Approved Section 4.55 (.....2.....) Modification Application

In respect to.....SSD 7484.....

SANDSTONE PRECINCT
23-39 BRIDGE STREET
SYDNEY, NSW, 2000

DEMOLITION ELEVATIONS LANDS BUILDING - SOUTH AND EDUCATION BUILDING - SOUTH

Date Printed: 29/6/20

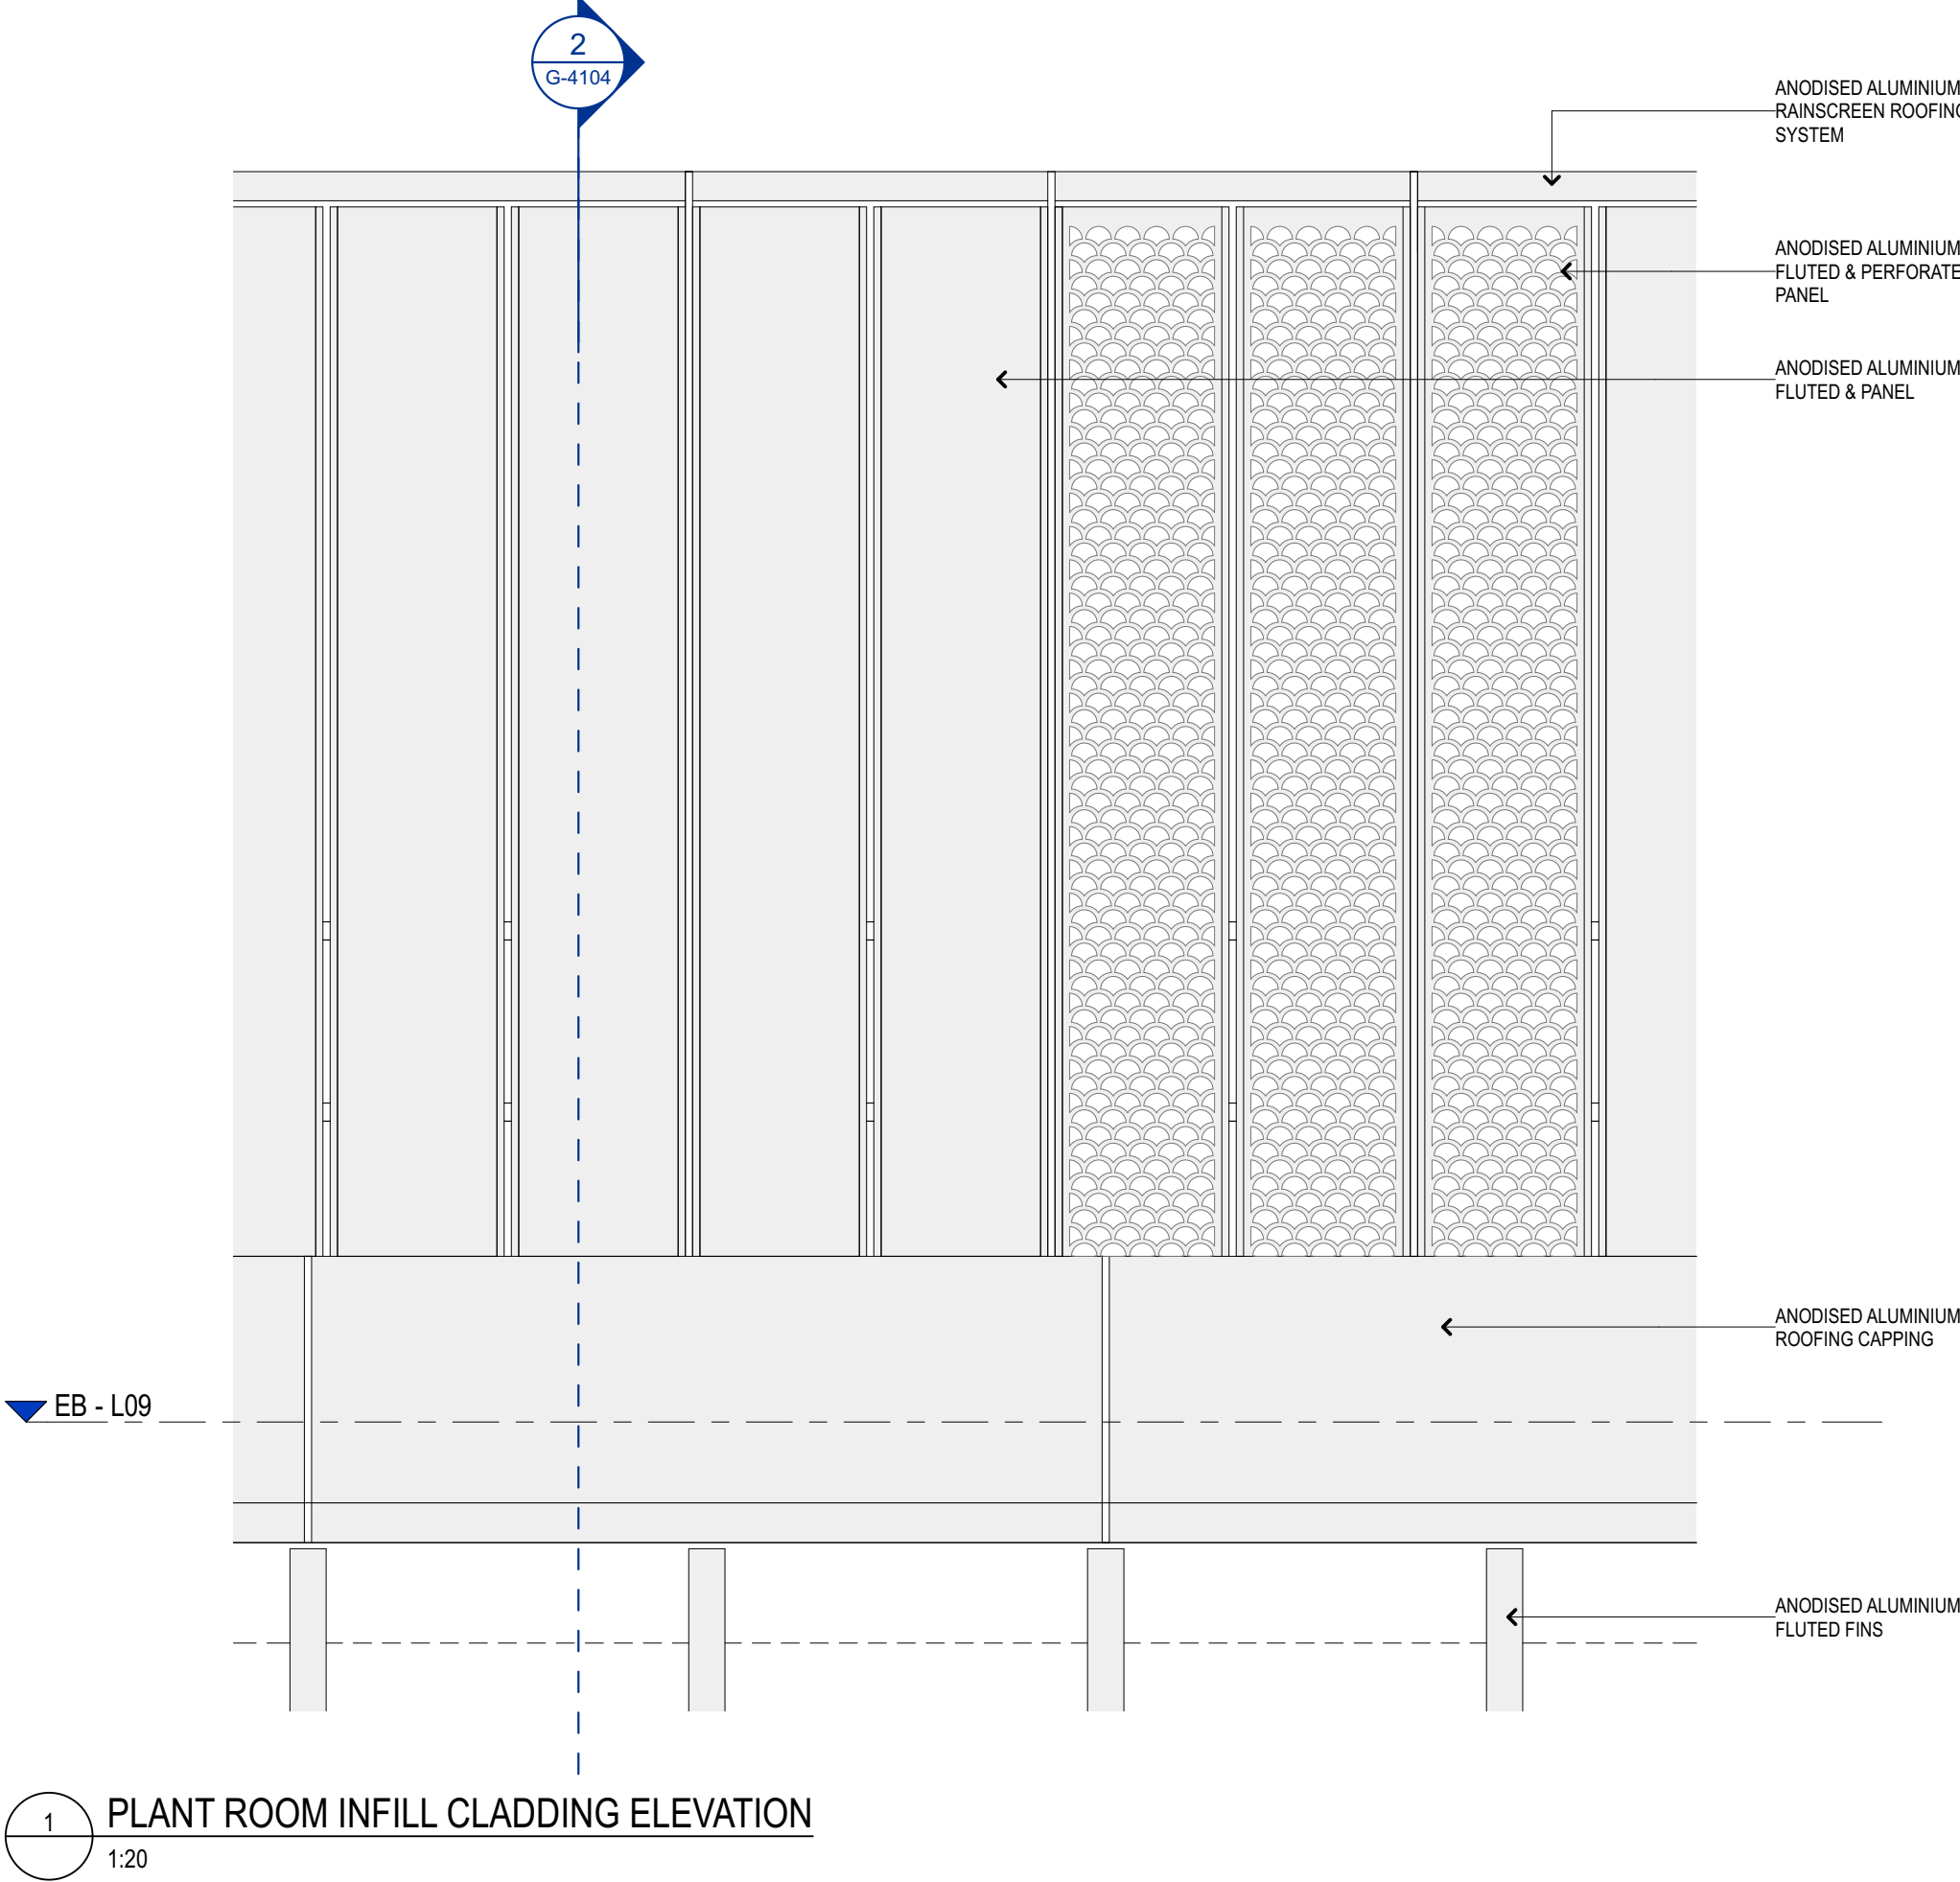
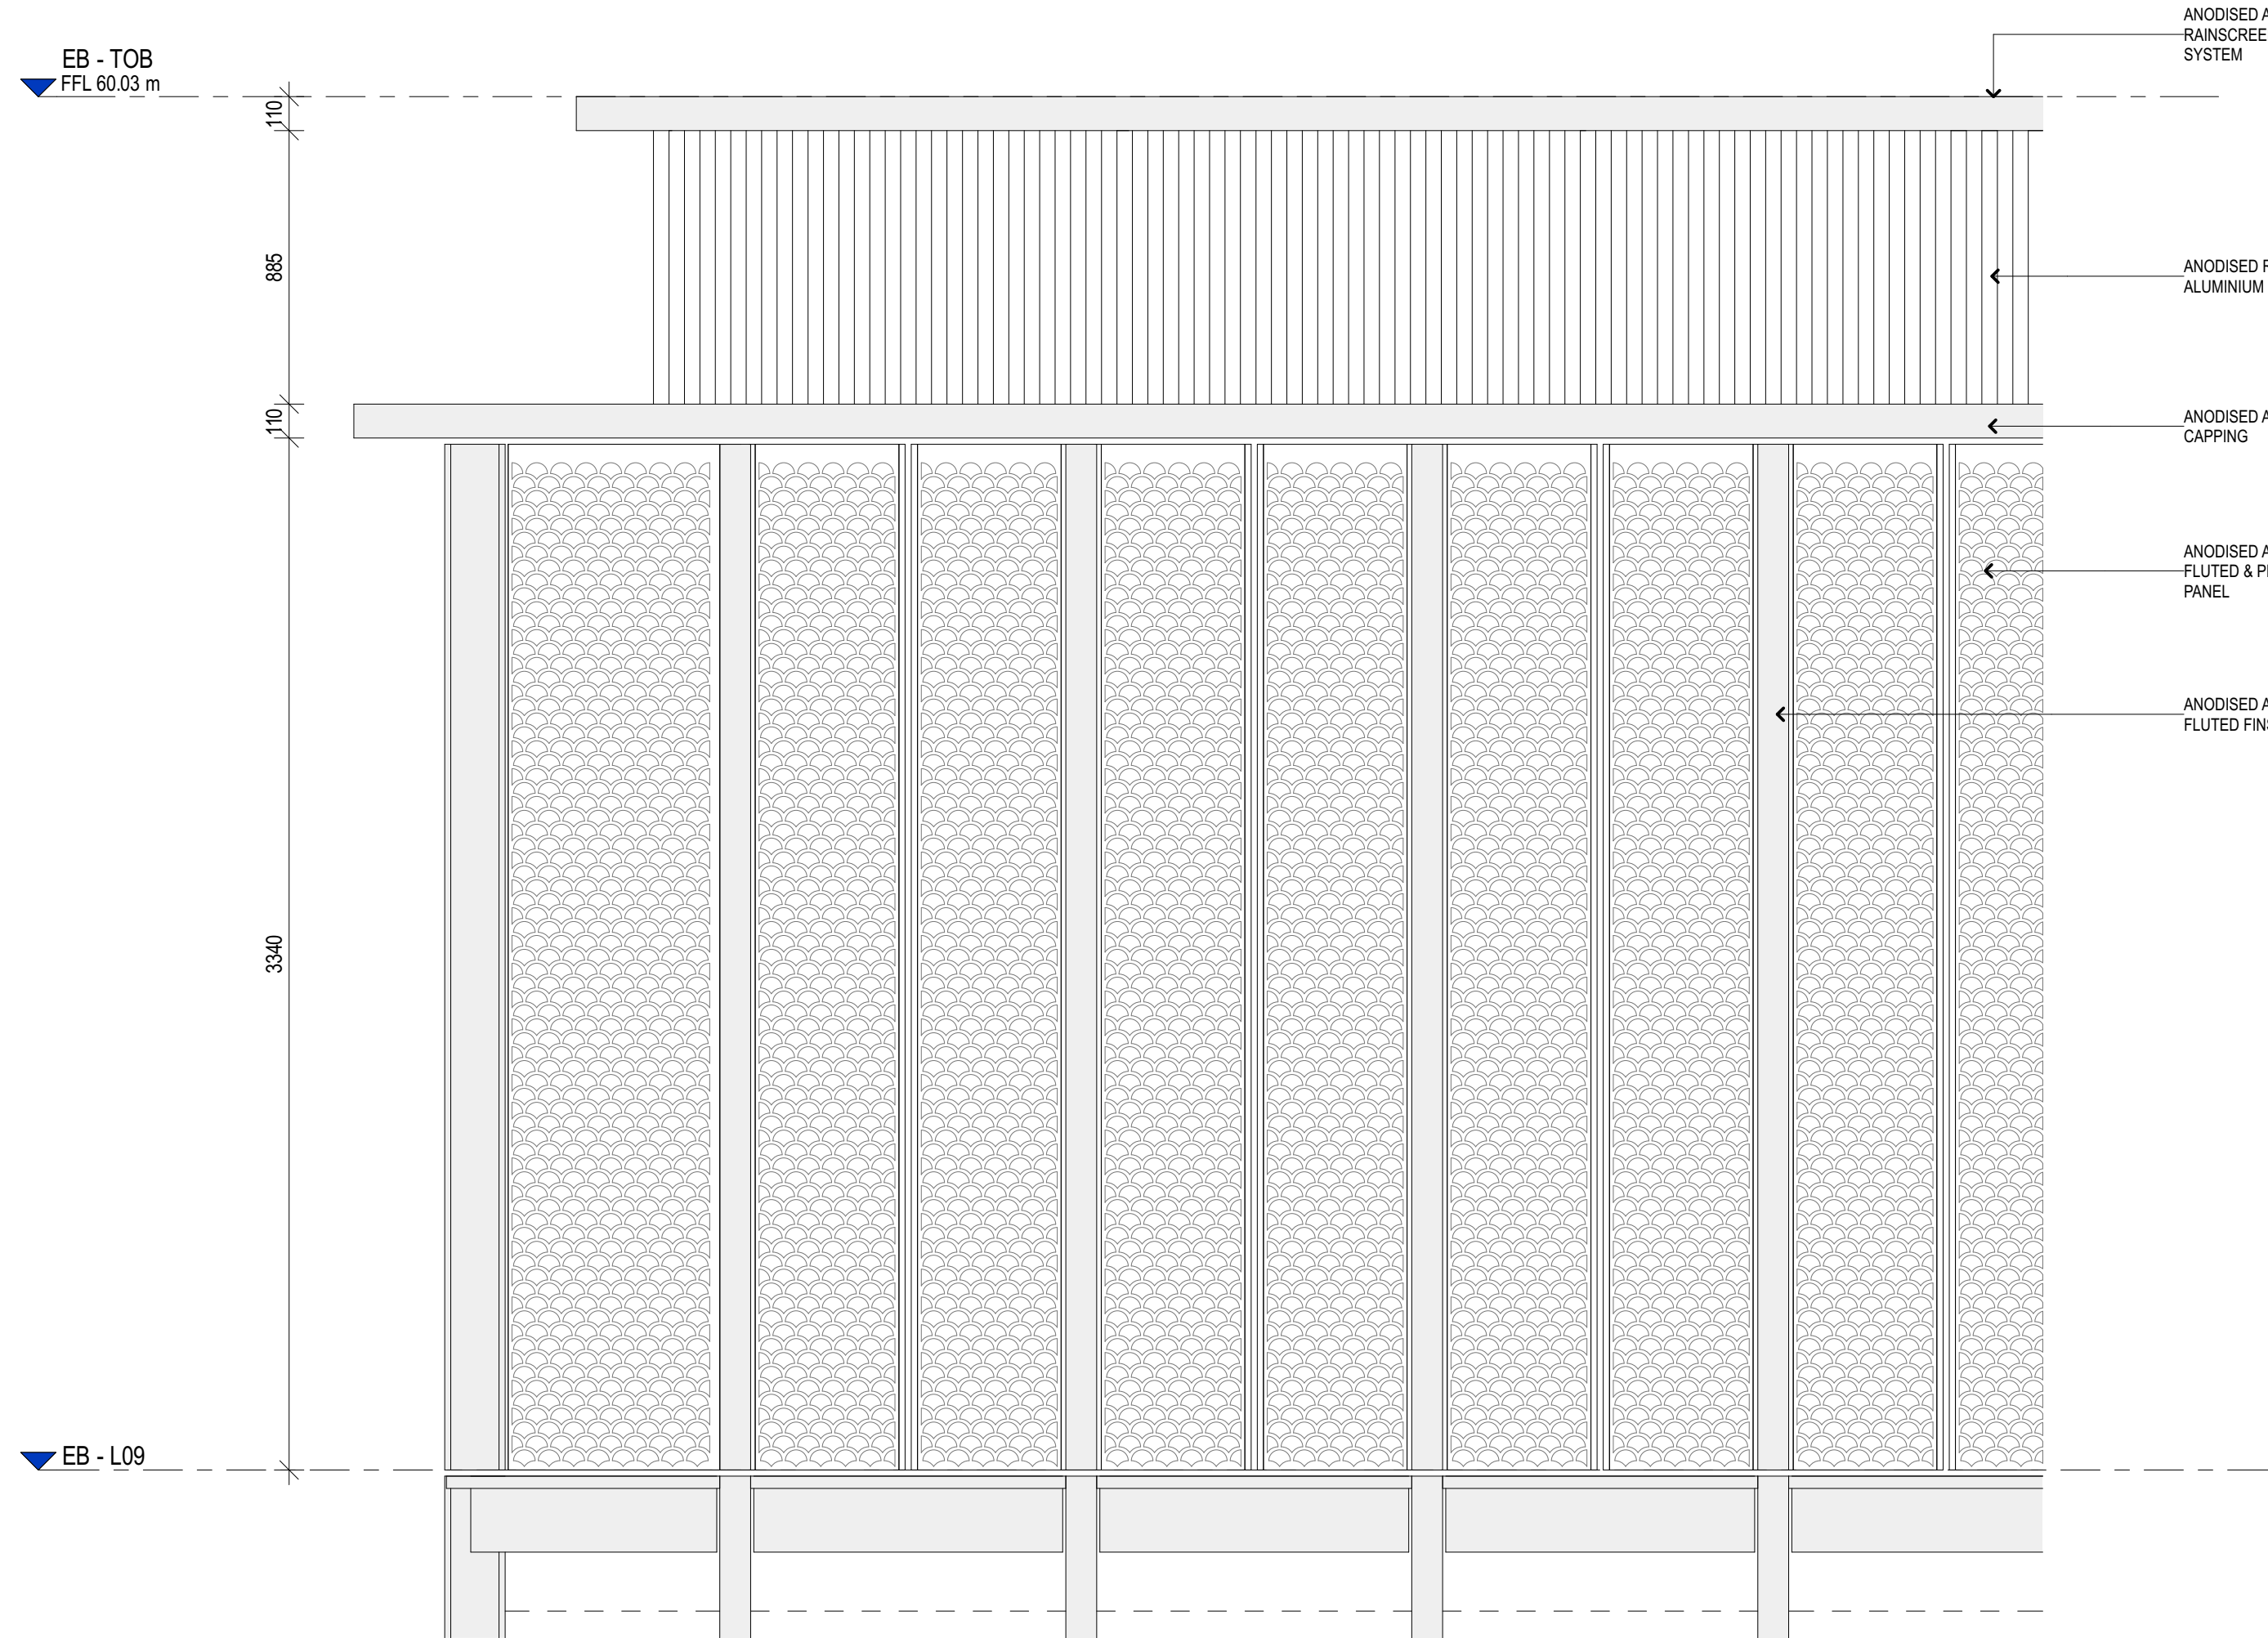
CHANGES LEGEND:
(01) ADDED BALUSTRADE
